UNIT 4

SeaTech Inc.
7552 NAVARRE PARKWAY, SUITE #7
NAVARRE, FLORIDA
(850) 939-3959
C.A. #28984

BUENA VIDA TOWNHOMES

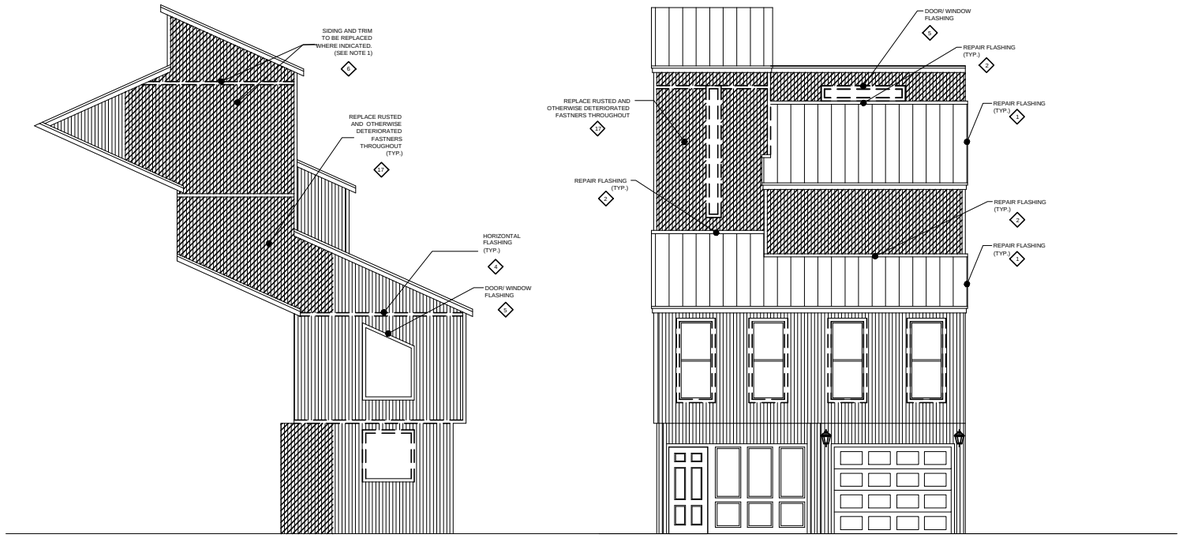
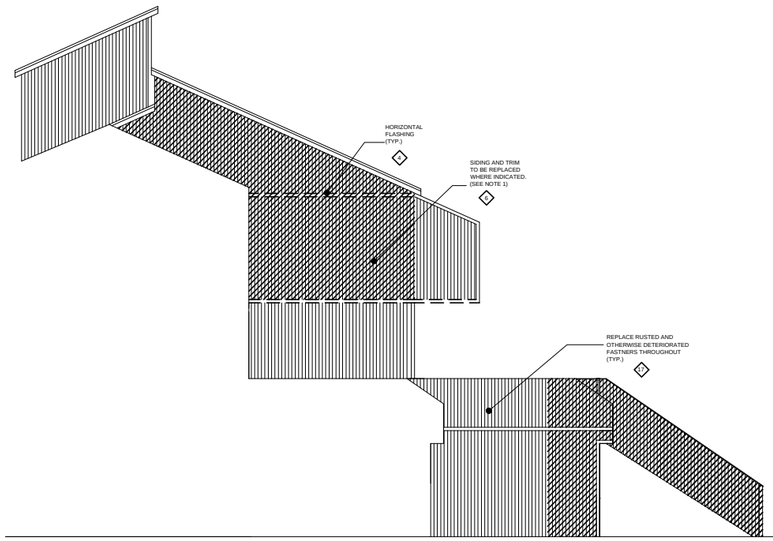
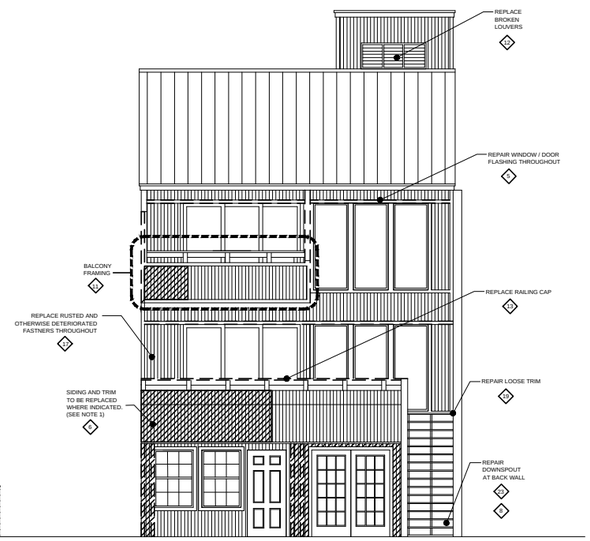
MARK	UNIT 4:
1	THE WALL / ROOF FLASHING IS RECOMMENDED TO BE INSTALLED PER DETAIL 1
2	THE WALL / ROOF FLASHING IS RECOMMENDED TO BE INSTALLED PER DETAIL 2.
4	THE HORIZONTAL FLASHING BETWEEN UNITS IS RECOMMENDED TO BE INSTALLED PER DETAIL 4. REPAIR LOOSE HORIZONTAL TRIM.
6	ANY ROTTED OR OTHERWISE DETERIORATED WOOD ENCOUNTERED IS RECOMMENDED TO BE REPLACED WITH PRESSURE TREATED WOOD OF EQUAL SIZE
9	ANY ROTTED OR OTHERWISE DETERIORATED WALL FRAMING MEMBERS ENCOUNTERED ARE RECOMMENDED TO BE REPLACED WITH PRESSURE TREATED WOOD MEMBERS OF EQUAL SIZE. PROVIDE POSITIVE DRAINAGE AWAY FROM WALL.
11	IT IS RECOMMENDED TO REPAIR BALCONY STRUCTURES PER DETAIL 7
12	REPAIR BROKEN LOUVERS
13	REPLACE 1 X 4 RAILING CAP AT DECK
15	ANY ROTTED OR OTHERWISE DETERIORATED WOOD FRAMING MEMBERS AT THE STAIRS ARE RECOMMENDED TO BE REPLACED WITH PRESSURE TREATED WOOD MEMBERS OF EQUAL SIZE. VERIFY INSTALLATION DETAILS WITH ENGINEER OF RECORD.

17	FASTNERS TO BE PROVIDED ON ALL EXTERIOR ELEMENTS @ 6" SPACING MIN. CONTRACTOR SHALL USE COMPATIBLE GALVANIZED OR STAINLESS STEEL FASTNERS.
23	REPAIR DOWNSPOUTS
